Project: River Road Elementary School – Building and Site Construction
Title: Addendum No. 1
Contract No: CIP 410 307 001
Date: March 1, 2016
From: John Stapleton, PIVOT Architecture
To: Interested Bidders

This Addendum is available at <http://www.4j.lane.edu/bids/> and modifies the Project Manual, Specifications, and Drawings in accordance with the Invitation to Bid and the Instructions to Bidders as follows:

3 RAINWATER SKID DETAIL
N.T.S.

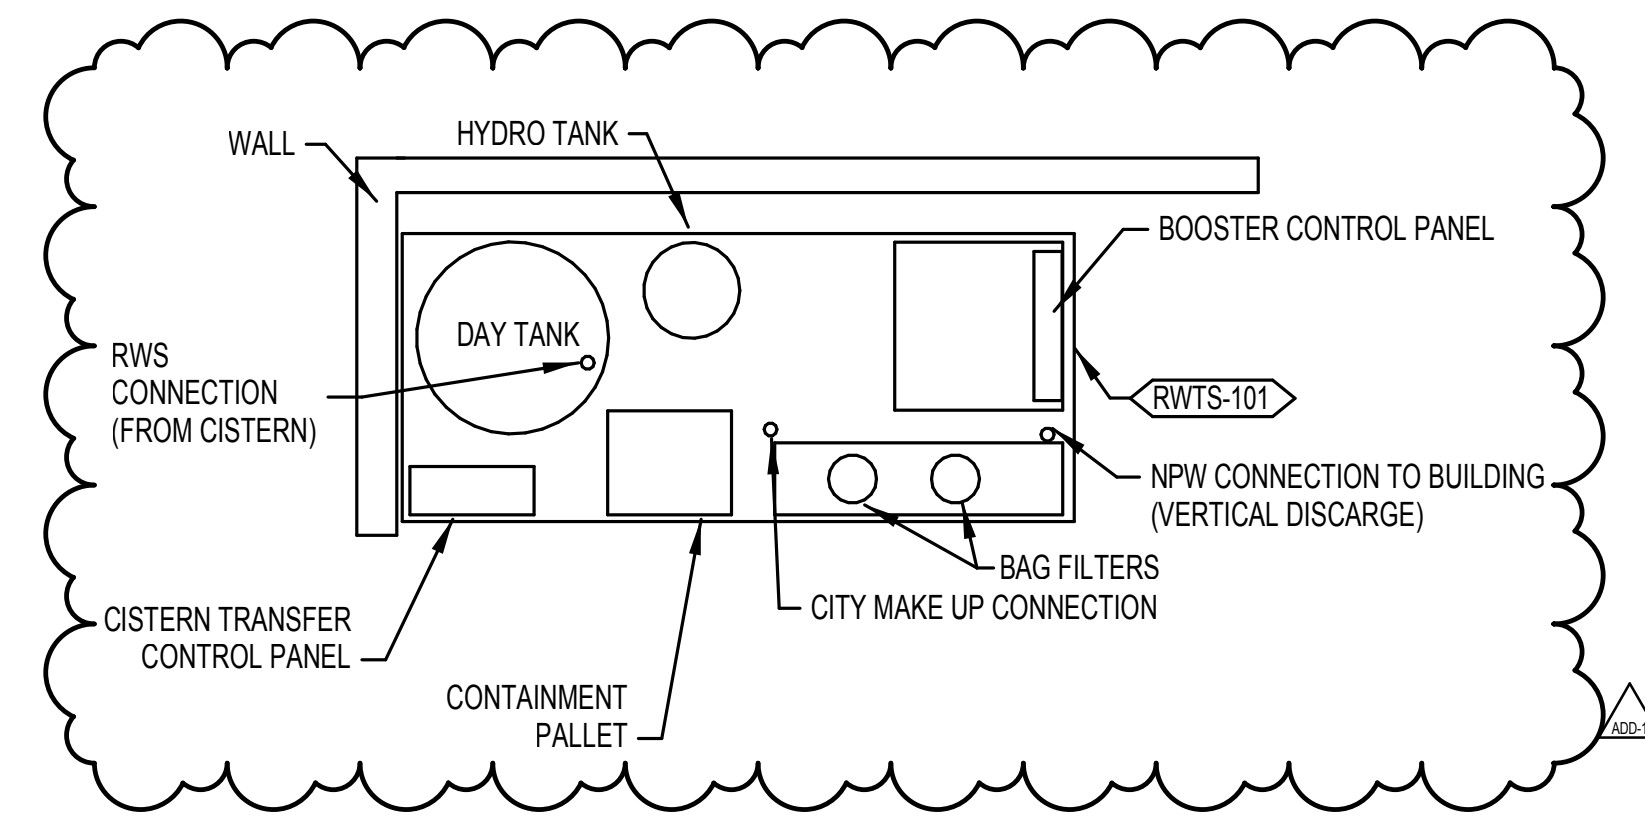
- 1-3-17 Sheet P502. Detail 3: Revise Rainwater skid piping connection locations. Detail 1: Revise and indicate all piping connections. Add general note B regarding alternate 7. Detail 2: Correct pump tag. Add to note 1 clarification regarding location of solenoid valve.

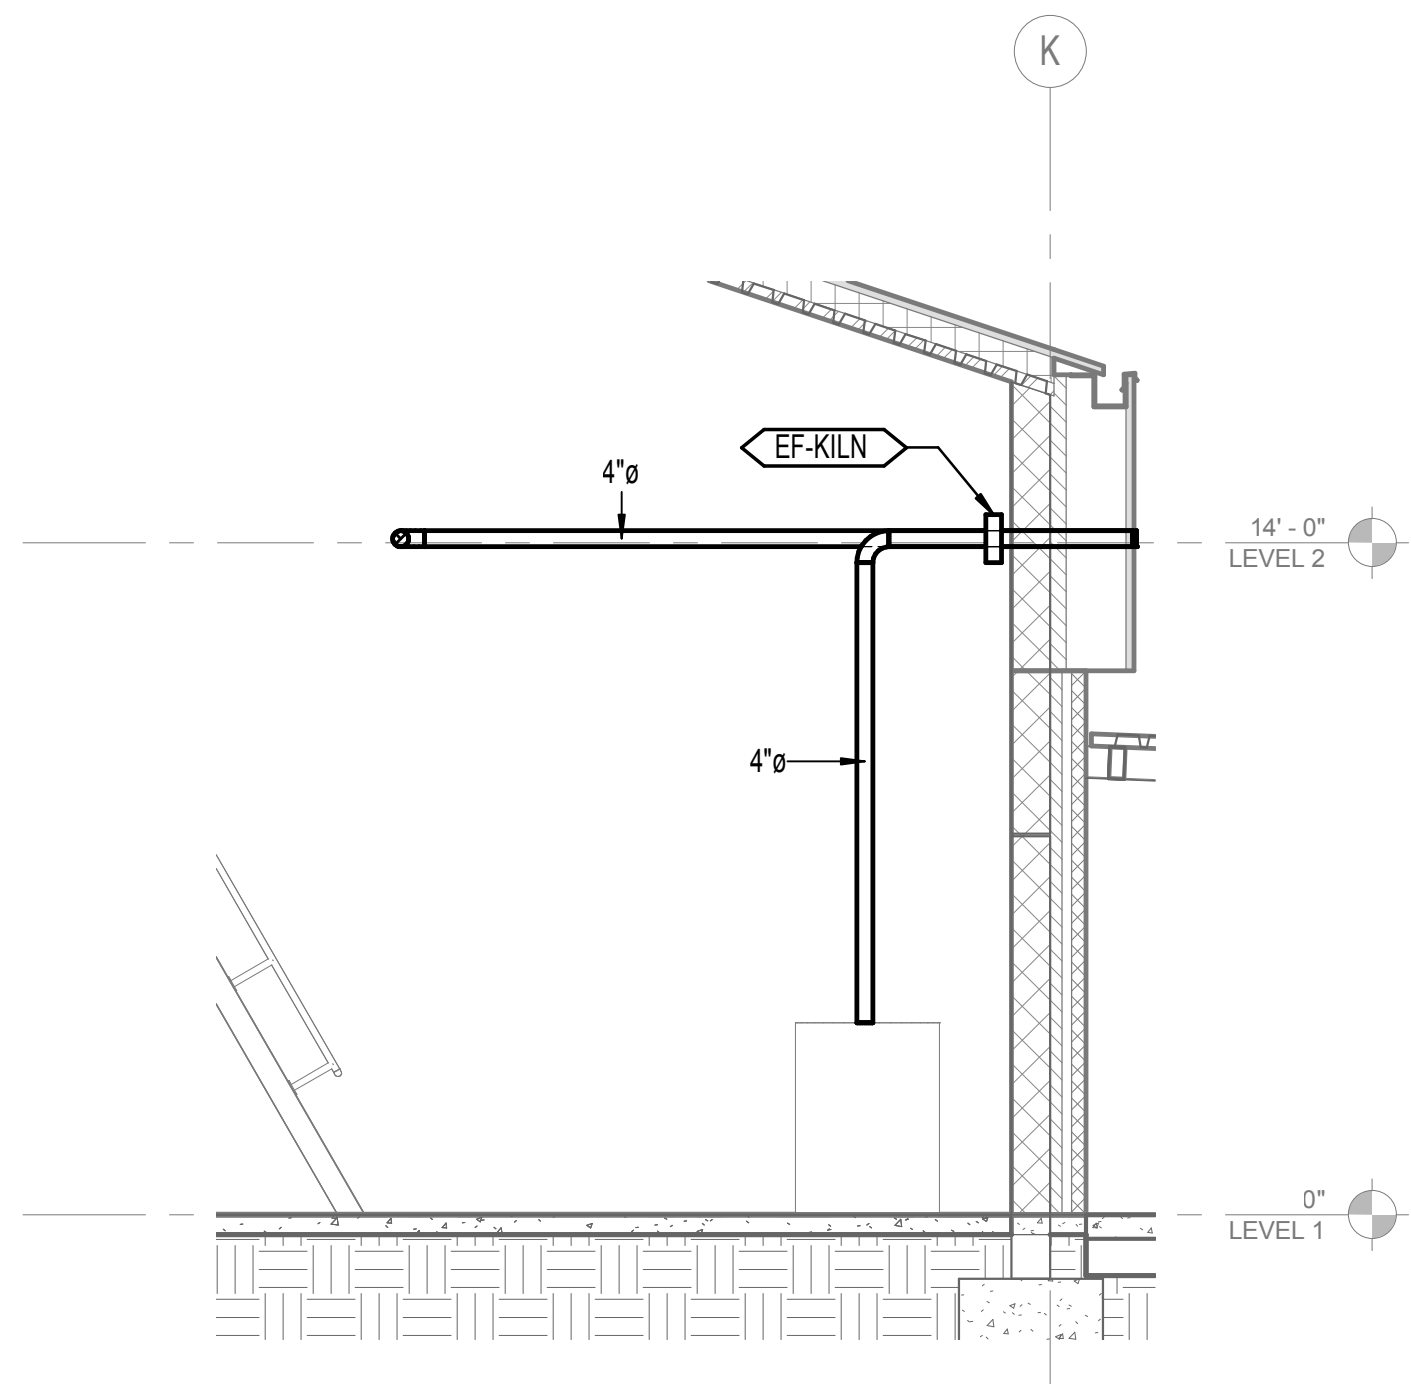
- 1-3-18 Sheet P601. Revise note 1 to 1 gpm per balance valve.
- 1-3-19 Sheet M115. Revise CUH-HALLC to provide some supply air to restroom, relocate exhaust grille. Relocate ACCU-ELECT. Add Note 26, regarding alternate 6, chiller deletion.

NOTES:
(1) SET BALANCE VALVES TO 1.0 GPM.

E011

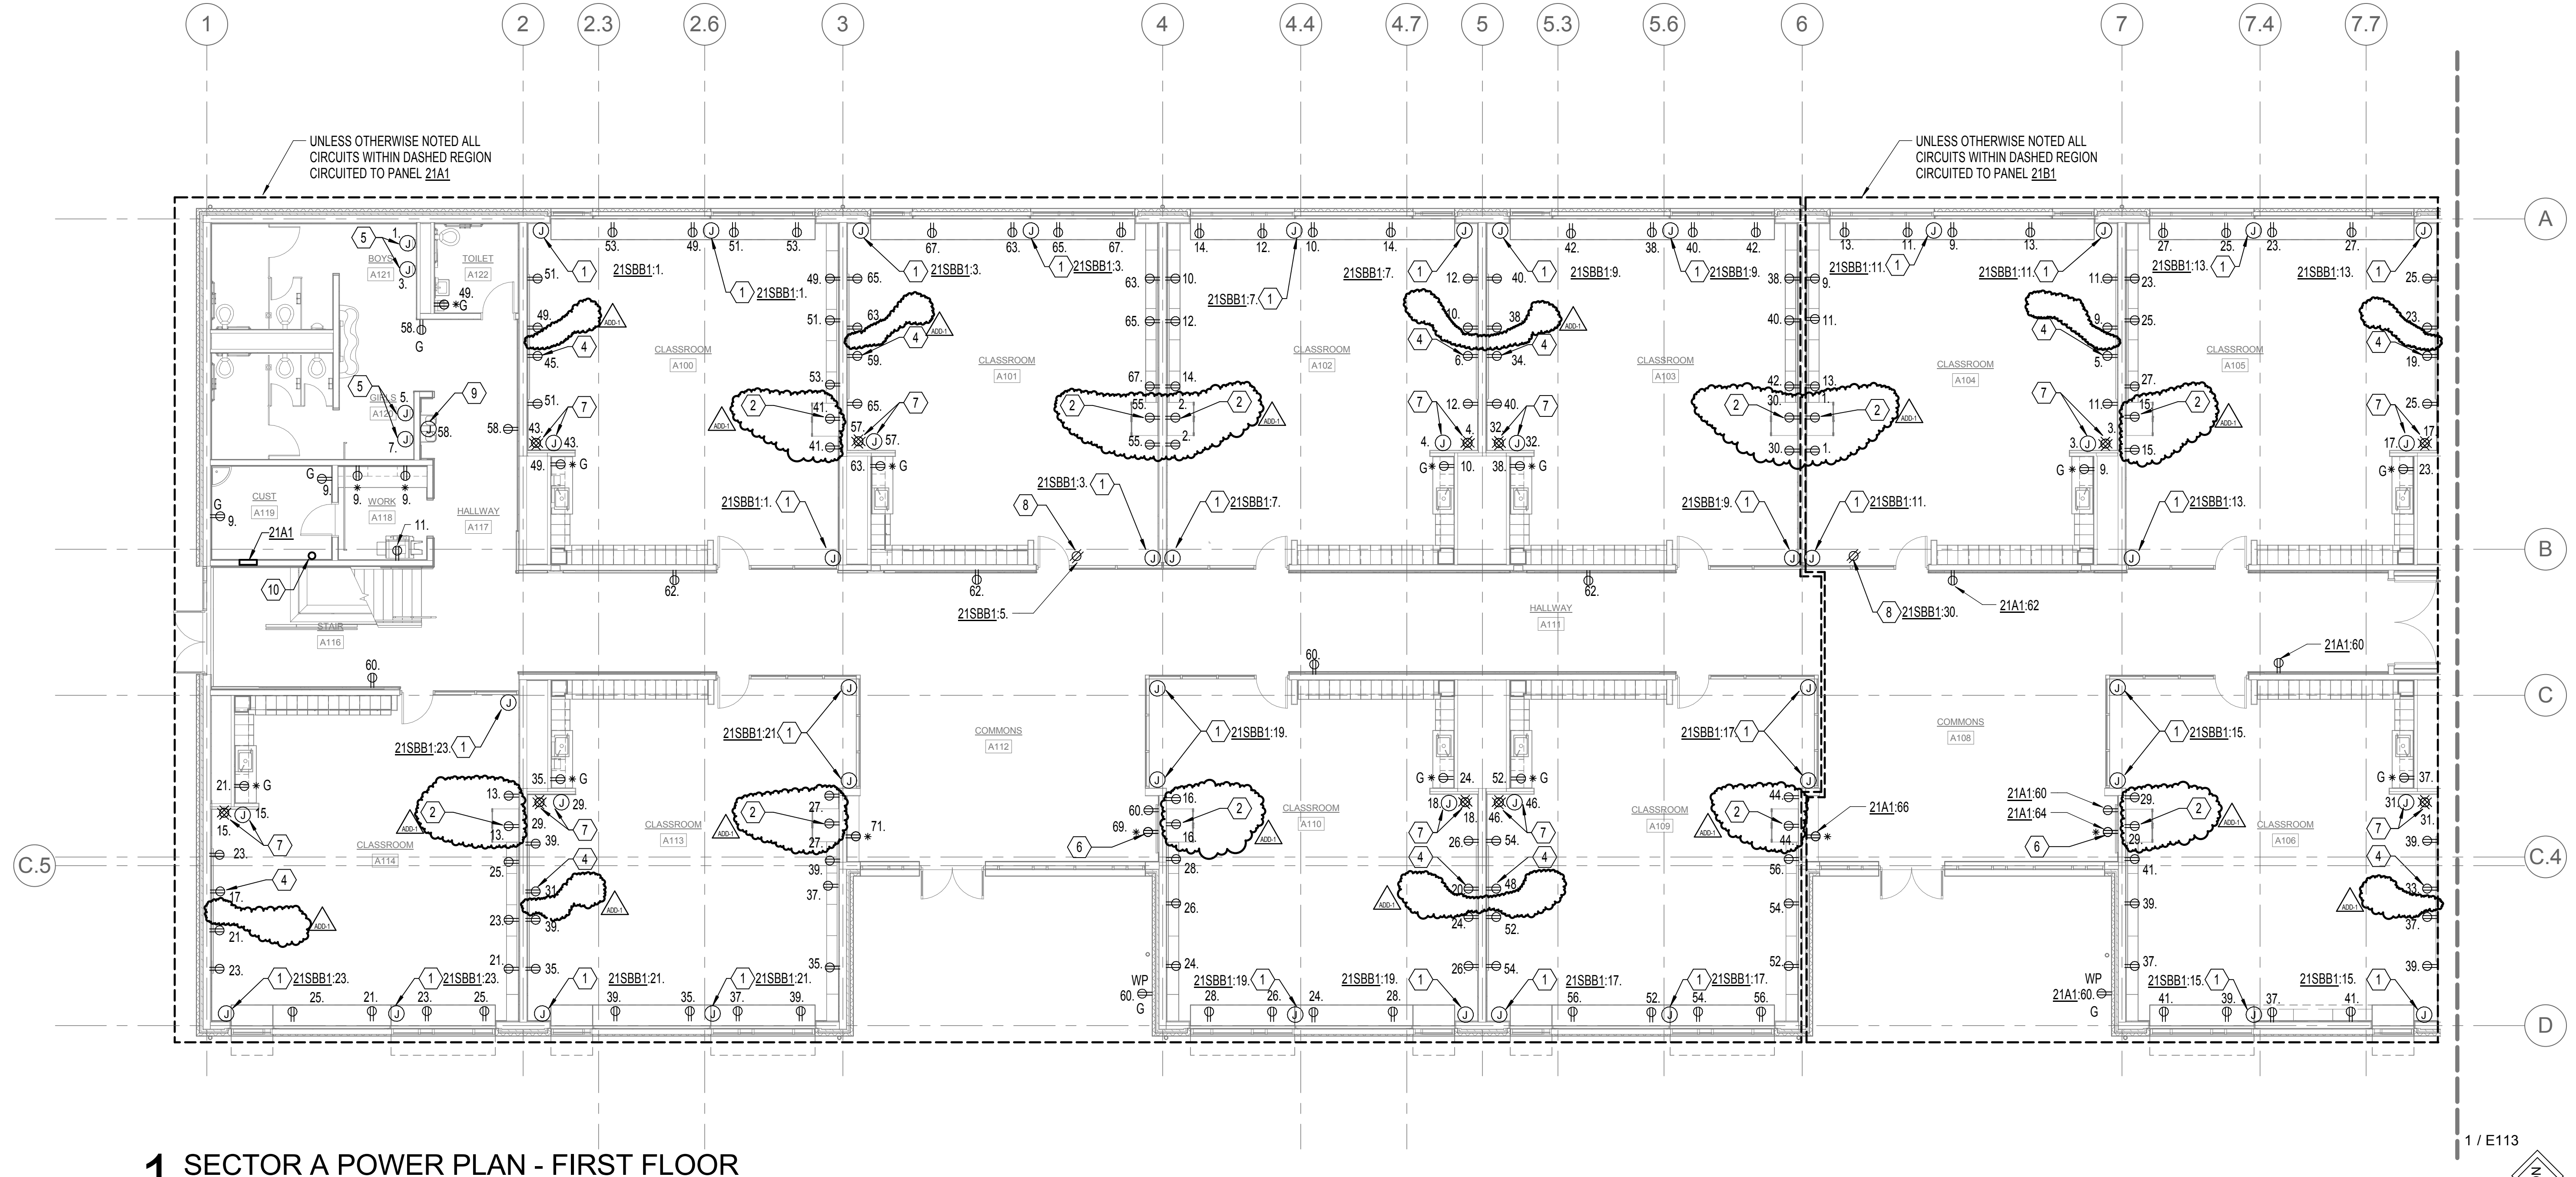
- 1-3-21 Sheet E011. Revise tag to note Alternate 2.
- 1-3-22 Sheet E111. Revised receptacle layout at tablet charging, removed tv receptacles.
- 1-3-23 Sheet E121. Revised receptacle layout at tablet charging, removed tv receptacles.

E131

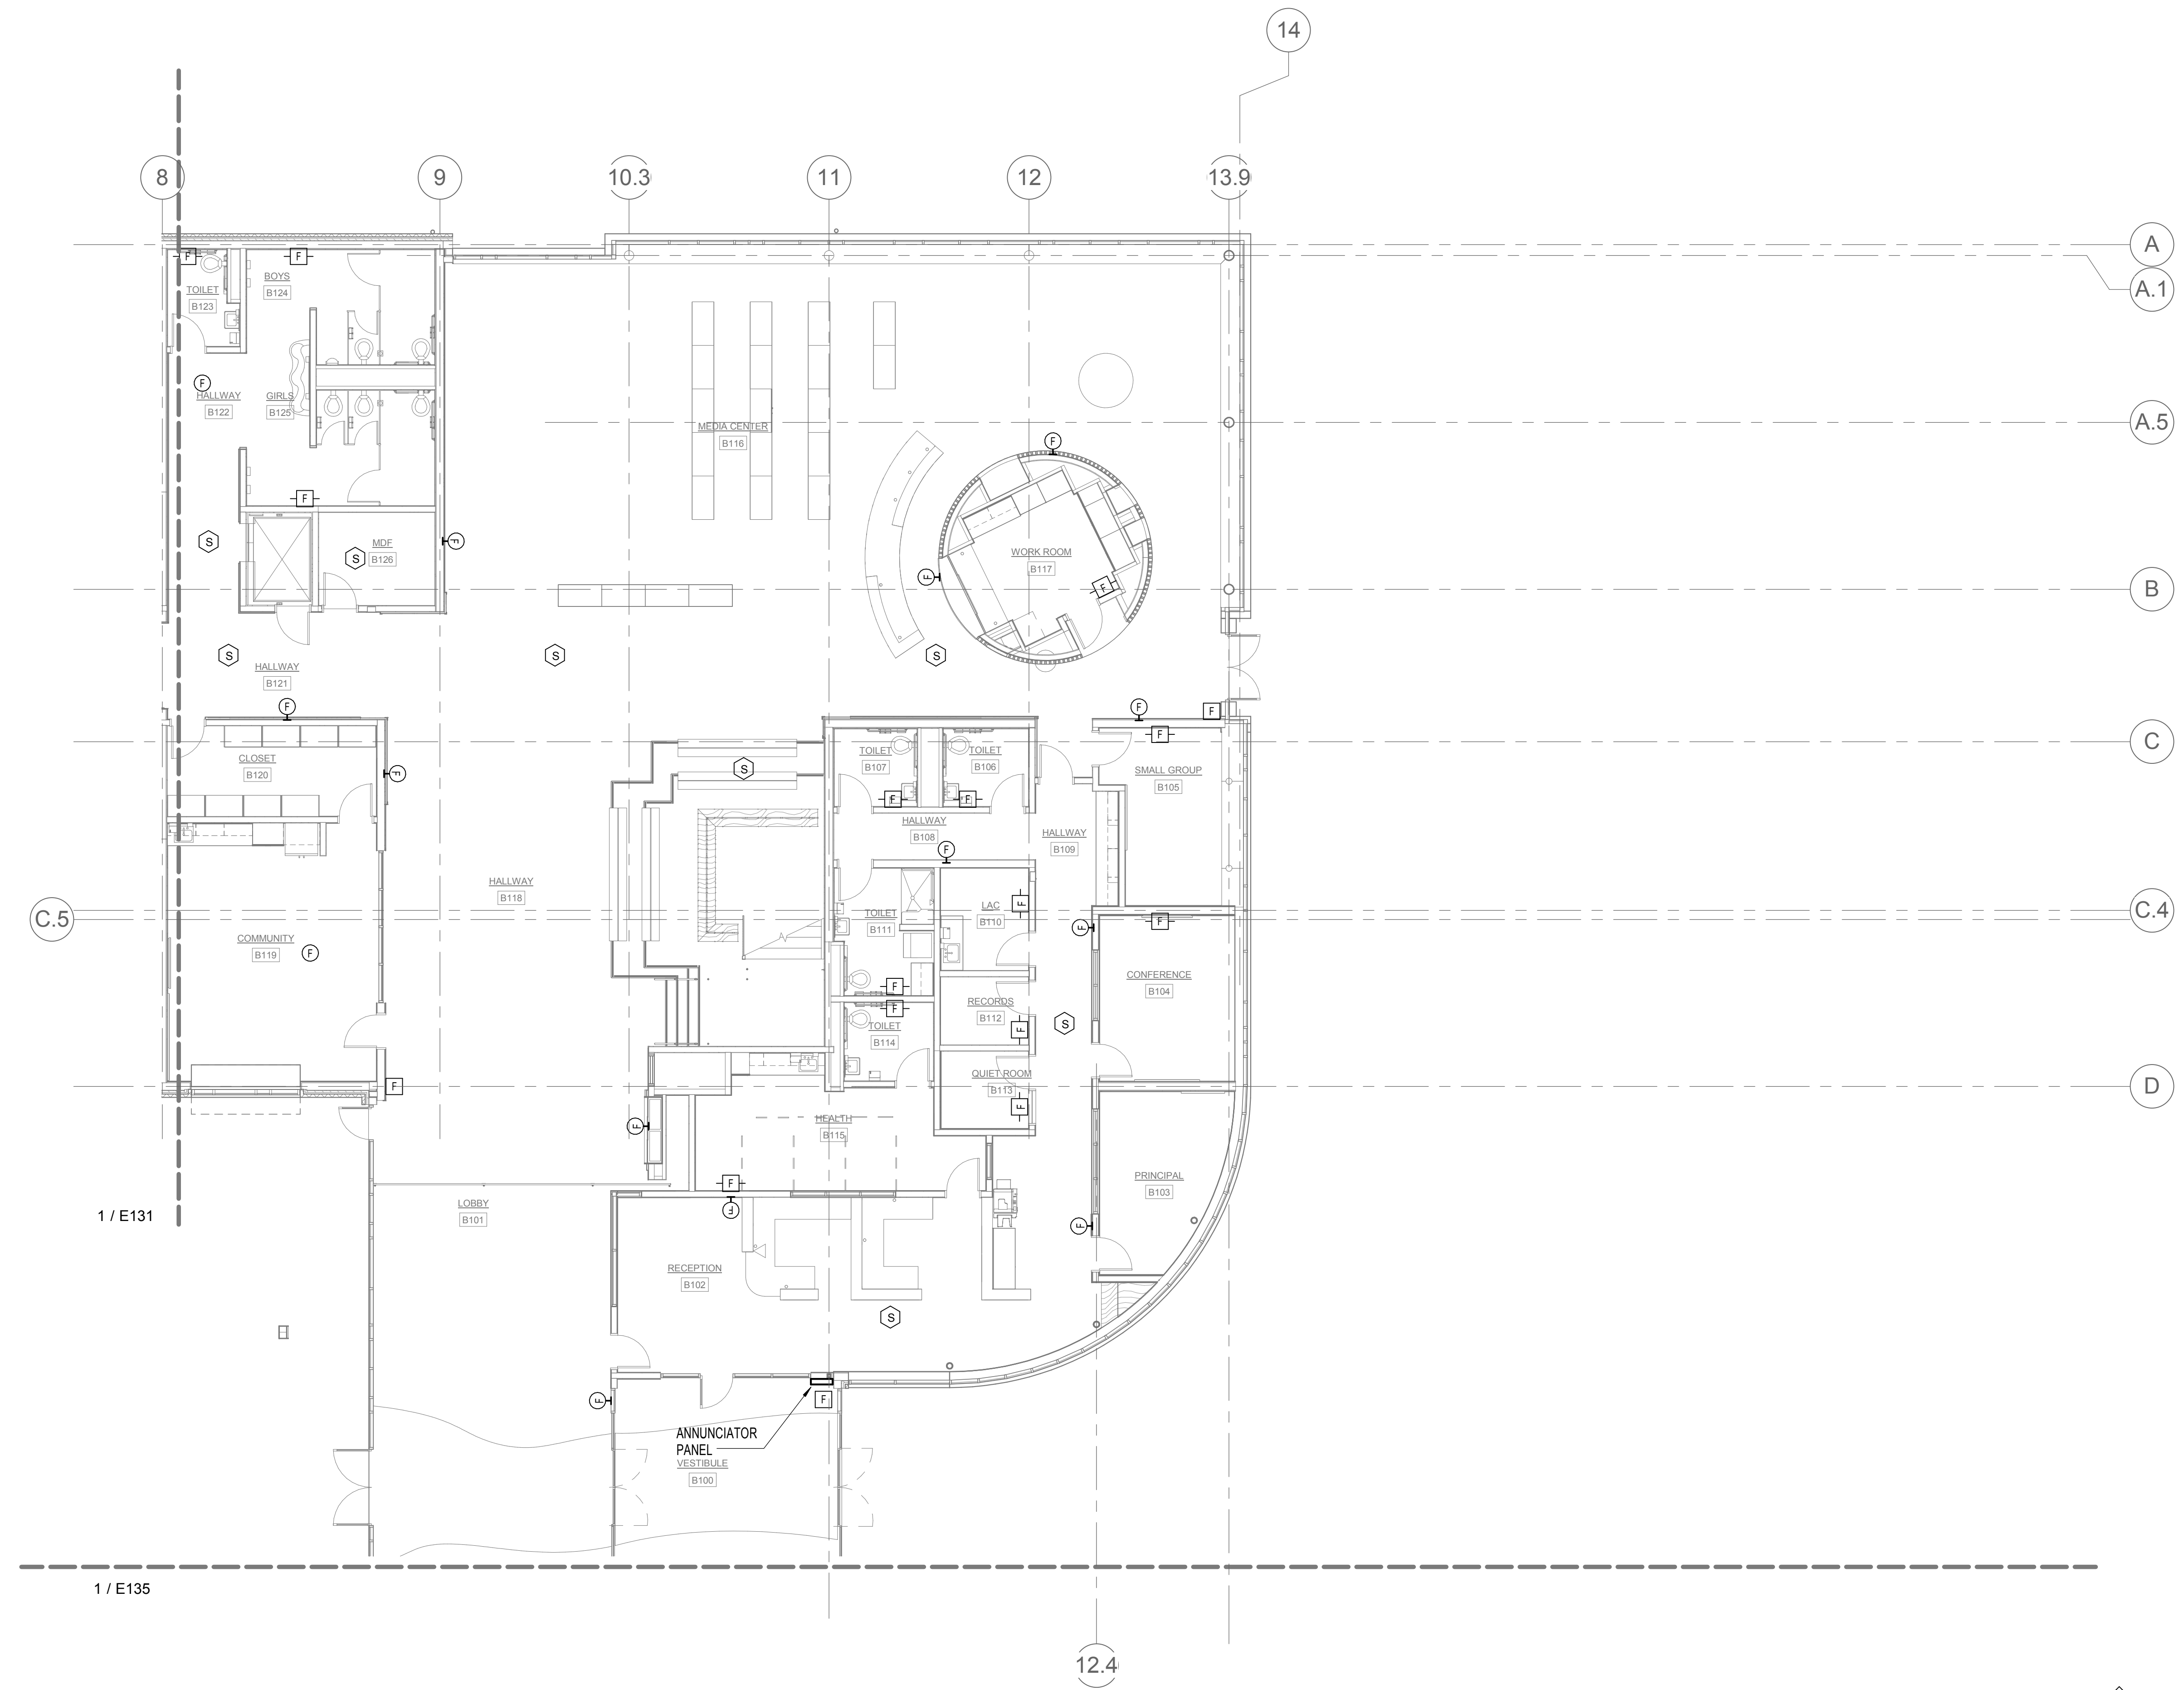
- 1-3-23 Sheet E131. Revised fire alarm general note.
- 1-3-24 Sheet E133. Revised fire alarm general note.
- 1-3-25 Sheet E141. Revised fire alarm general note.
